**Item 7.****Development Application: 11-17 Eve Street, Erskineville****File No.:** D/2017/1393**Summary**

<b>Date of Submission:</b>	11 October 2017  Amended plans submitted on 12 December 2017, 3 May 2018 and 13 June 2018
<b>Applicant:</b>	Frontier Property Development Group Pty Ltd
<b>Architect:</b>	Smith & Tzannes
<b>Developer:</b>	Frontier Property Development Group Pty Ltd
<b>Owner:</b>	Frontier Property Development Group Pty Ltd
<b>Cost of Works:</b>	\$5,559,336
<b>Land Use:</b>	Permissible in B4 Mixed Use zone.
<b>Proposal Summary:</b>	<p>Development application for the demolition of existing buildings, tree removal, and construction of a three and five storey residential flat building. The development includes 19 dwellings and one basement level with parking for 20 vehicles.</p> <p>The application is referred to the Local Planning Panel for determination as the State Environmental Planning Policy No.65 applies.</p> <p>The preliminary assessment of the application, including consideration of the proposal by the City's Design Advisory Panel, identified landscaping and amenity issues associated with solar access. The proposal has been amended during the assessment to address

Figure 21: The southern elevation.

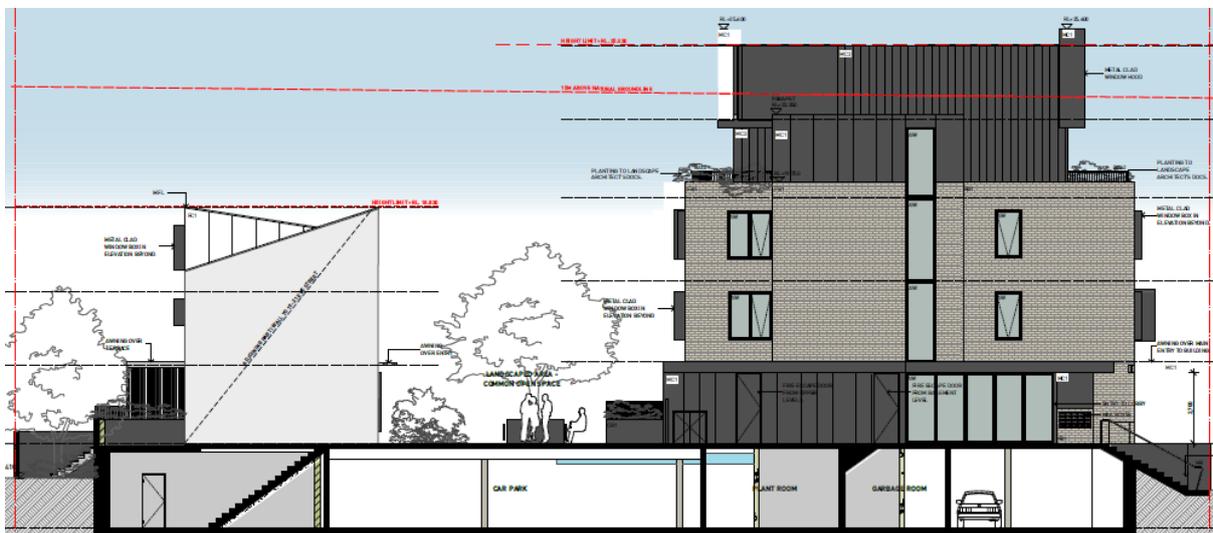
Figure 17: Eve Street elevation. It is noted that the upper red line does not correctly indicate the height controls for the site.

Figure 22: Basement plan of 19-21 Eve Street with breakthrough panel circled.

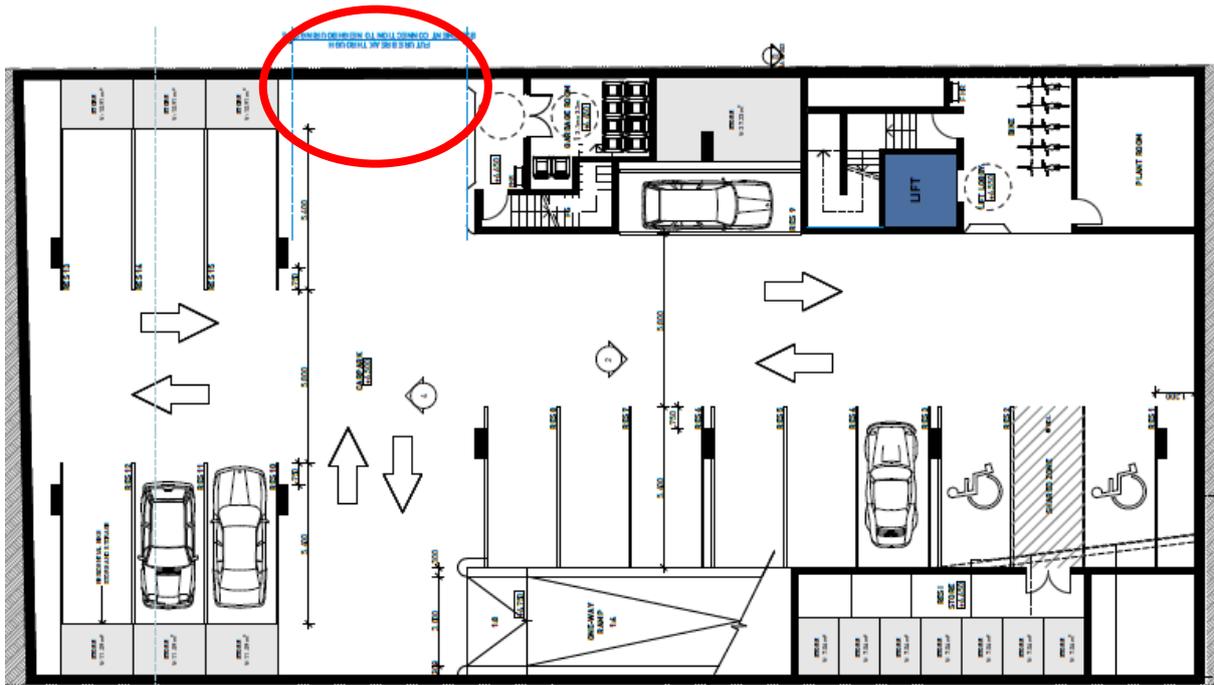
24. To the south of the site at 19-21 Eve Street, development consent (D/2014/1805/A) was issued for demolition of the existing industrial buildings, excavation of basement for 15 car spaces, construction of five storey and three storey residential flat building comprising 18 residential units with internal communal open space. This development is currently under construction.
25. The approved development incorporates a shared pedestrian entry, and shared driveway with basement connection through a breakthrough panel into the subject site.
26. The proposed development generally replicates the architectural style and layout of this approval.

Figure 27: The Ashmore height in storeys map from Sydney DCP 2012.

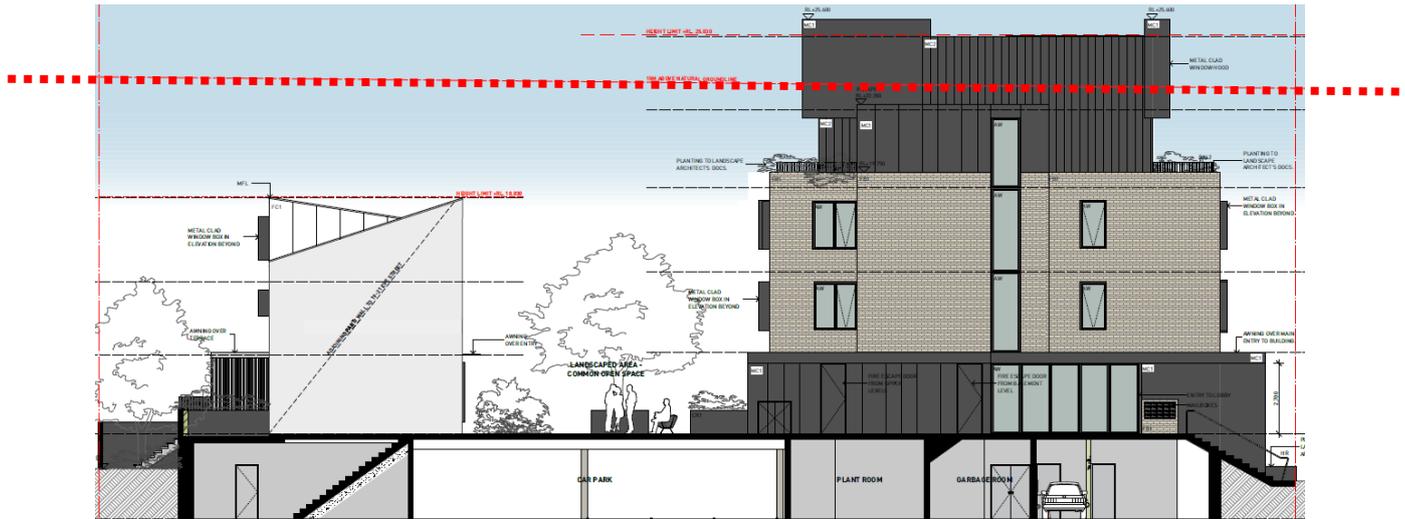
41. The 12m height control is an anomaly within the LEP height controls map. This has been reviewed by Council's strategic planning unit who have confirmed that the 12m height control over 13 Eve Street is an error. It is inconsistent with the Ashmore Neighbourhood controls within the Sydney DCP 2012 which permit 4 storey development across the site, as shown in Figure 27 below.

**Figure 30:** Views from the sun diagrams at midwinter.

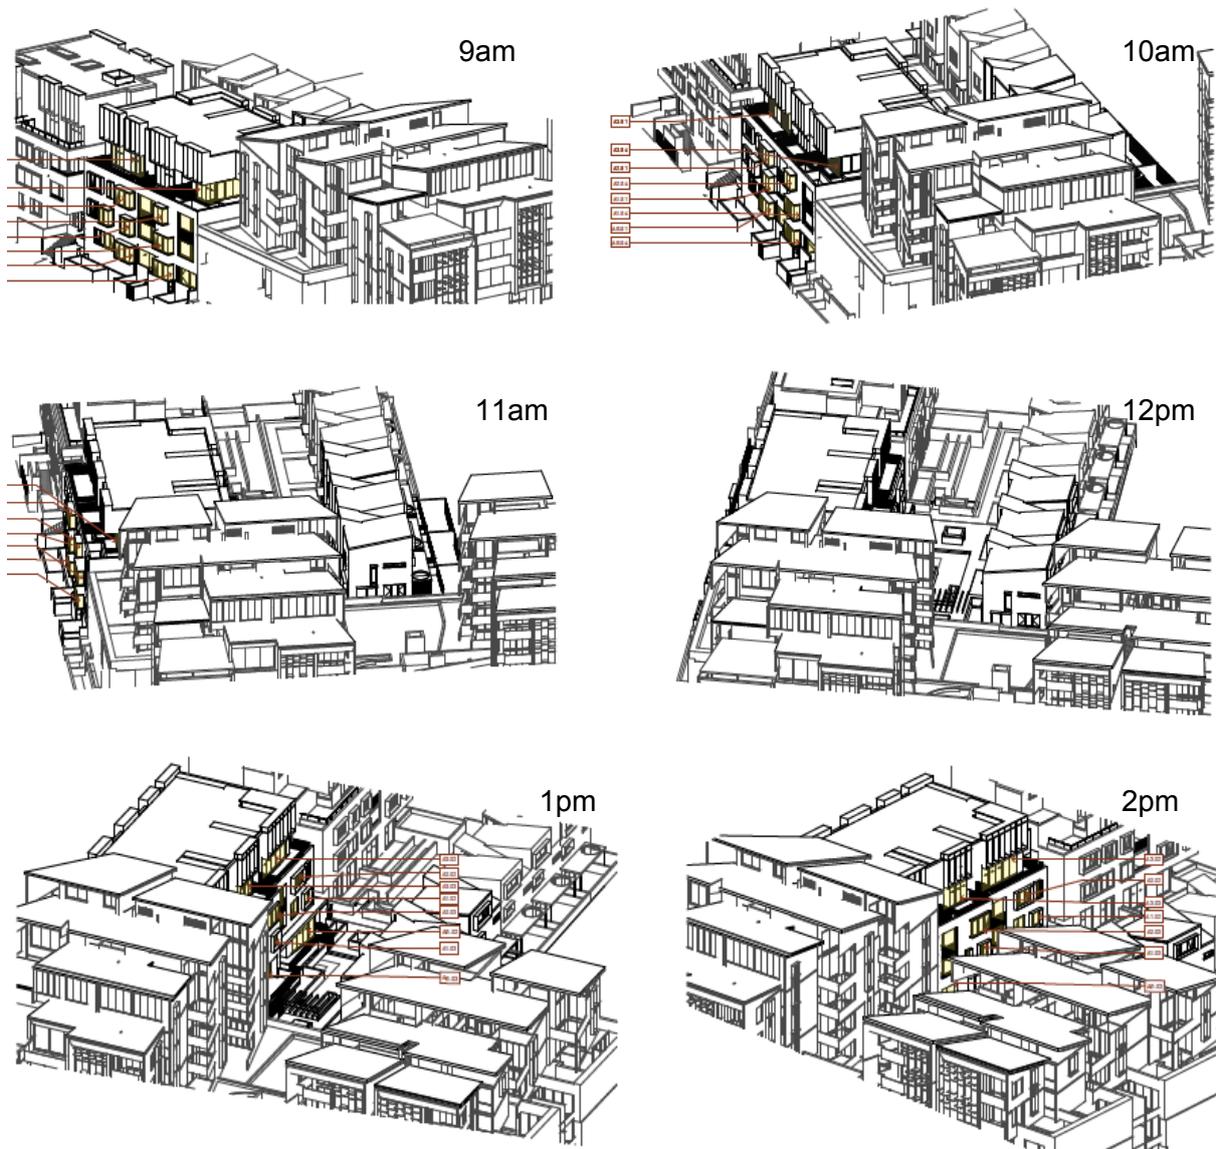
54. The Eve Street facade faces east allowing units facing east to receive direct sunlight from 9am. The application has been amended to ensure that all living rooms fronting Eve Street achieve two hours of direct sunlight at midwinter through the provision of projecting bay windows which enable the sunlight to be captured at an oblique angle at 11am. These amendments have increased the number of units achieving two hours direct sunlight from 26.3 per cent (5/9) to 57.9 per cent (11/19) of units.

55. It is noted that 17/19 (89.5 per cent) of apartments receive one hour of direct sunlight, whilst only 1/19 (5.2 per cent) of apartments received no direct sunlight which complies with the ADG requirement for a maximum of 15 per cent to receive no sunlight.

56. The design of the Luxe development to the north of the site extends past the rear building line of the proposed development which restricts many of the units facing west from achieving two hours of direct sunlight. There are no reasonable amendments possible that could assist with additional units achieving direct sunlight at midwinter. The proposal is considered to be acceptable as the units achieve an overall high level of amenity. Additionally the built form as proposed is consistent with the typology outlined by the DCP of providing a higher building form to Eve Street and lower building form to the rear of the site which is separated by a central courtyard, as shown in Figure 27 above.

57. The ADG also requires that developments achieve a minimum of 50 per cent direct sunlight to the principal usable part of the communal open space for a minimum of two (2) hours between 9am and 3pm on 21 June (midwinter). The proposed communal open space achieves direct sunlight for one hour between 12pm and 1pm as it is overshadowed by the 'Luxe' development to the north of the site at other times of the day. The communal open space is provided at ground level in a location identified by the DCP and is considered to be a useable open space area. The provision of communal open space at rooftop level is not appropriate in this instance as it would result in further breaches to the height control and would not be consistent with the continuous built form of surrounding developments including 19-21 Eve Street to the south of the site.

**Figure 32:** Extract from Figure 5.105 of the Ashmore Street Hierarchy.

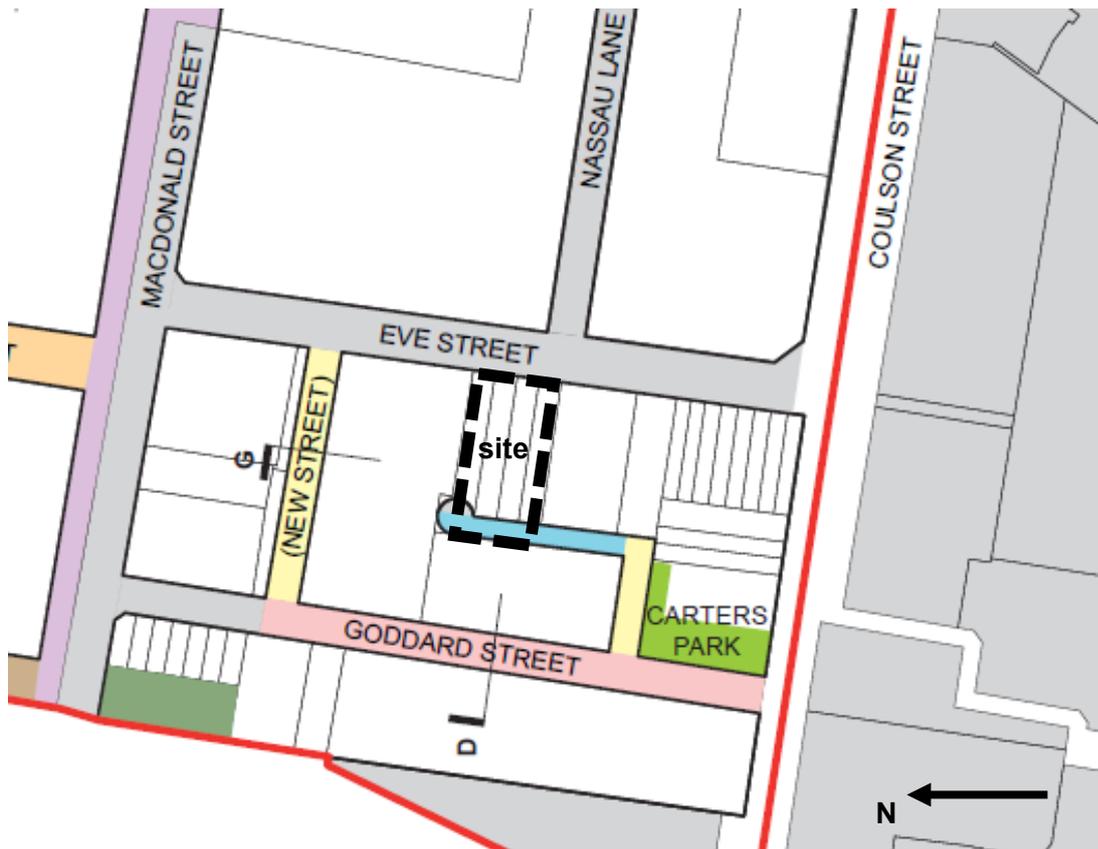
- 62. The Sydney Development Control Plan 2012 identifies a new 6m wide lane, known as Goddard Lane, to be located at the rear (west) of the subject site. This lane is a "no through road".
- 63. The proposed lane, shown in blue in Figure 32 below, is created by the dedication of a 6m strip of land from the rear of the subject site (outlined in dashed line) and neighbouring properties in accordance with the Ashmore Precinct Site Specific Controls of the SDCP.

64. The provision of Goddard Lane was considered during the assessment of the neighbouring development at 19-21 Eve Street (D/2014/1805). It was determined by the City's Strategic Planning team that Goddard Lane was no longer required for the overall redevelopment of Ashmore. In particular it is noted that the lane is not strategically required for access/circulation purposes within the Ashmore road network, and is not required to "break up" the future street block, which is of a similar size to other blocks within the precinct. Subsequently, land was not dedicated for the purpose of a laneway as part of the development for 19-21 Eve Street, and the dedication of land is therefore not required for the subject site.
65. An amendment to the Sydney Development Control Plan 2012, removing Goddard Lane is planned to be undertaken in due course.
